Memorandum to the City of Markham Committee of Adjustment

File: A/156/18
Address: Block 16, Registered Plan 65M-2457 (14th Ave) Markham
Applicant: True Jesus Church (Apostolic Faith) Canada
Agent: TAES Architects Inc. (Shenshu Zhang)
Hearing Date: Wednesday, November 13, 2019

1 Site Plan
1 : 300

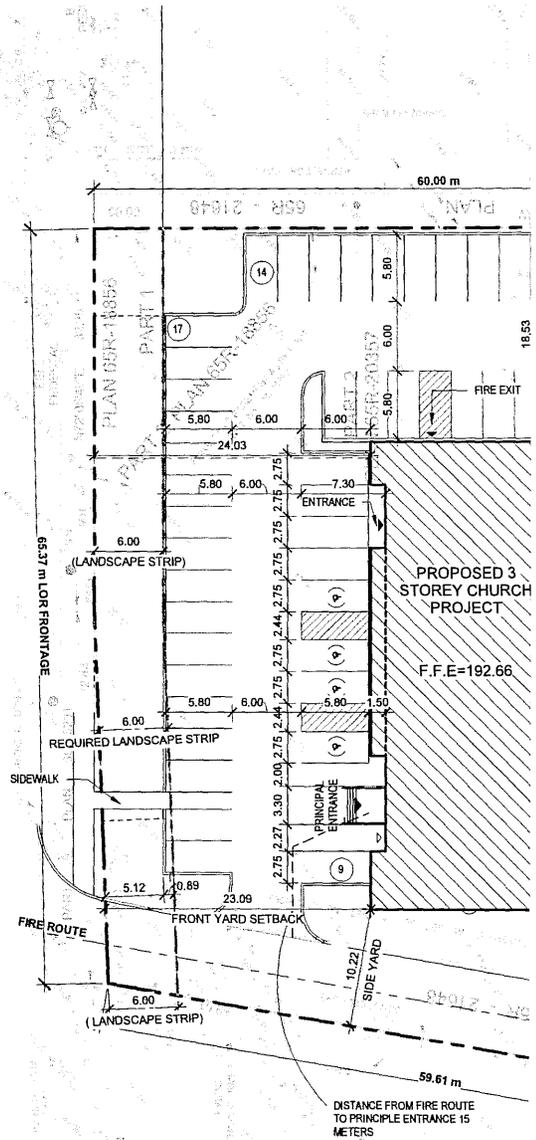
The initial minor variance application requested relief from the by-law to allow parking spaces to encroach 2.18 m into the landscaped open space. Urban Design Staff have worked with the Applicant to reduce the encroachment onto the landscaped open space to 0.89 m to allow for additional required parking spaces, while maintaining an adequate landscaped open space width of 5.11 m at the narrowest point, as shown on Appendix "B".

The proposed development includes 80 parking spaces, whereas 88 spaces are required as per the City's Parking By-law 28-97. This will result in a deficiency of eight parking spaces, which is a reduction of approximately 9.1 percent. Transportation Engineering staff are of the opinion that the variance is minor and is unlikely to result in any significant impact on the parking supply of the property.

The initial minor variance application requested 76 parking spaces, whereas 97 were required. A number of the originally proposed parking spaces were 5.2 m in length, whereas spaces are required to have a length of not less than 5.8 m. Staff have worked with the Applicant to reconfigure the parking lot to accommodate four extra parking spaces and reduce the GFA of the building to require seven less parking spaces. Additionally, the proposed development was revised to ensure that all parking spaces met the minimum length requirement in the by-law of 5.8 m. Staff have no objections to the approval of the proposed parking reduction.
